Assessment of Blacktown City Council's Draft Section 94 Contributions Plan No 24

Schofields Precinct

Local Government — Assessment
August 2014

Figure 3.1 Location of Reserve 867

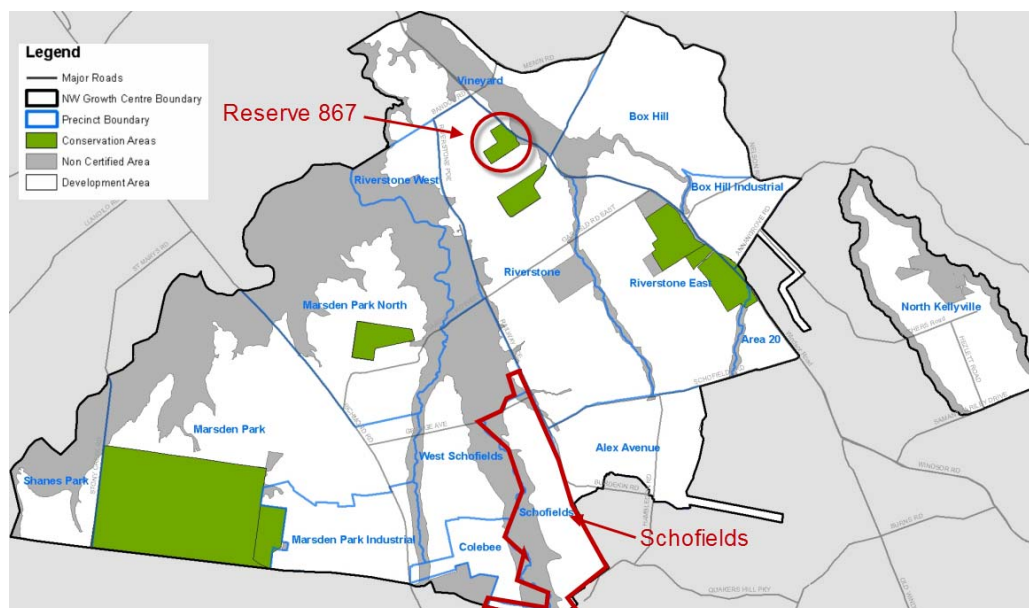
CP24 includes costs for a proportion of a conservation area of around 23 hectares, located in the Riverstone Precinct (marked as Reserve 867 in Figure 3.1).³¹ It will be accessible to the public as a bushland conservation area.³²

Figure 3.2 Location of open space infrastructure in CP24

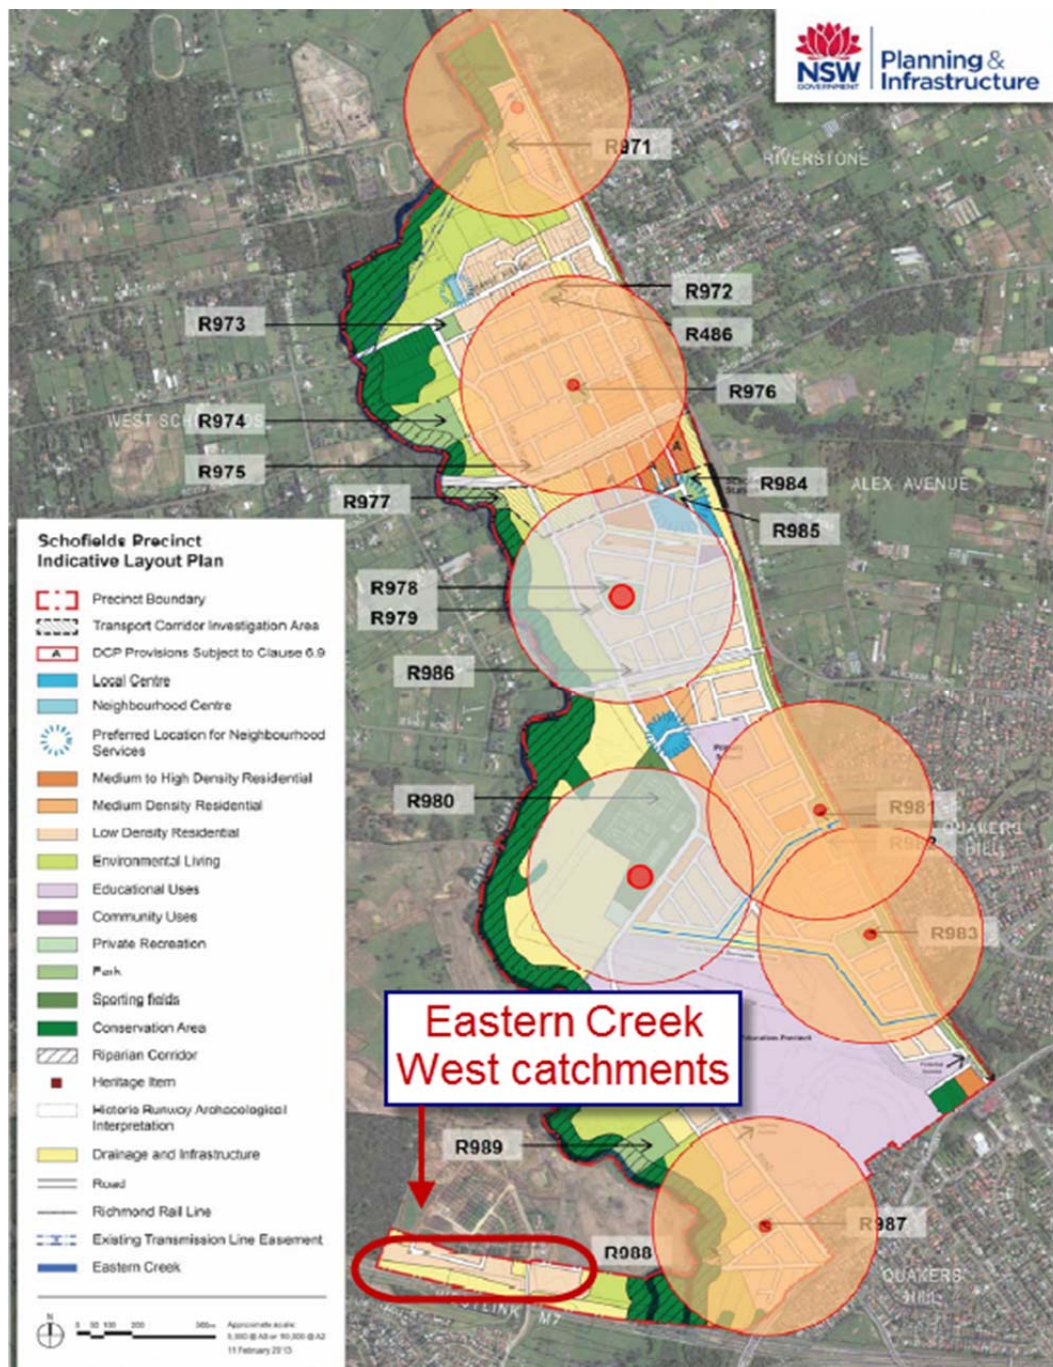
We consider that most of the apportionment is reasonable for open space infrastructure. However, we consider that it is not reasonable to include the catchments west of the Eastern Creek Precinct when apportioning the cost of local open space infrastructure. The catchments west of Eastern Creek are isolated and there does not appear to be reasonable access within 400 to 500 metres to local parks in the Schofields Precinct to justify the apportionment of costs (see Figure 3.2).
